<b>Dwelling type:</b>	Double Storey
<b>Dwelling configuration:</b>	House and Garage
<b>Nature of works:</b>	New Build
<b>Stage of inspection:</b>	Frame
<b>Construction Type:</b>	Hebel
<b>Garage:</b>	Attached
<b>Foundations:</b>	Waffle Slab
<b>Builder:</b>

### **Defects, observations and other related comments from Frame Inspection on 15/11/2023.**

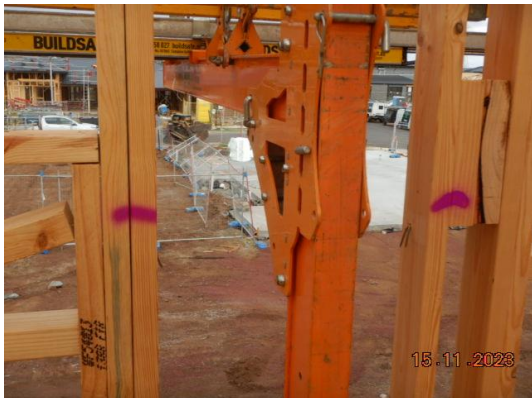
**21.**

**AS 4440; 3.10:** - If any timber truss is found to be damaged or manufactured in such a way as to impair performance, the truss engineer should be notified in order to provide adequate rectification to the truss.

Damage to this dwellings roof truss/s requires notification to the truss engineer as it is presents as severe enough to warrant attention.

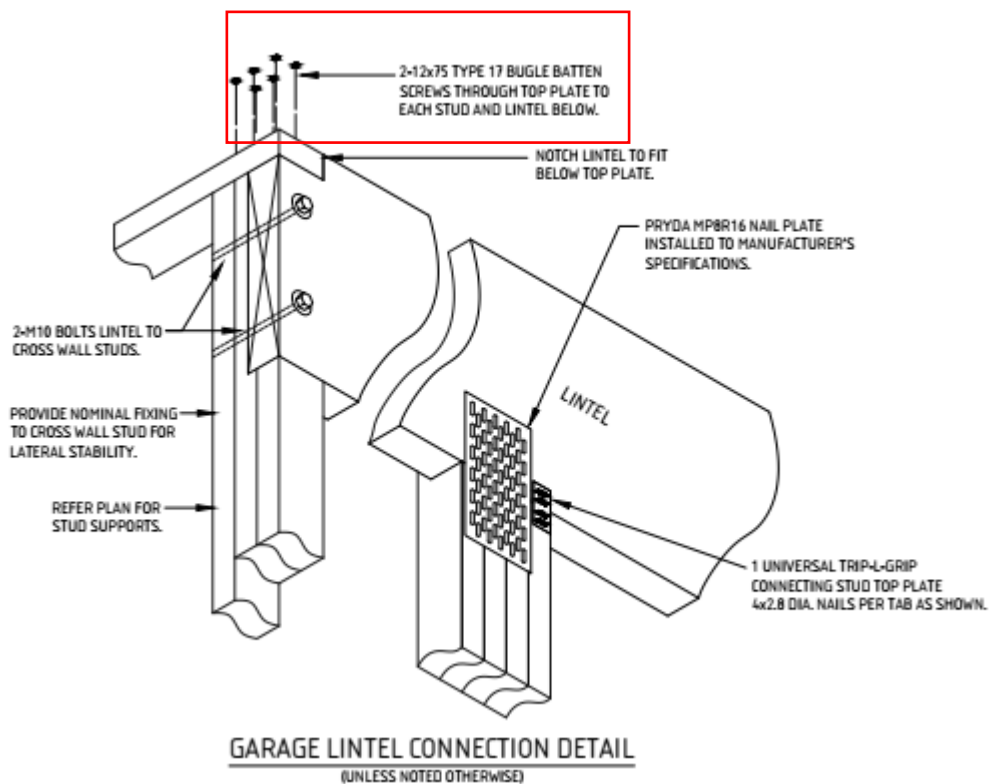
**The Domestic Building Contracts Act 1995; Implied Warranties, sect. 8(a):** - The building contractor warrants that work will be carried out in accordance with the plans and specifications set out in the contract.

The garage beam has not been connected as per engineering.
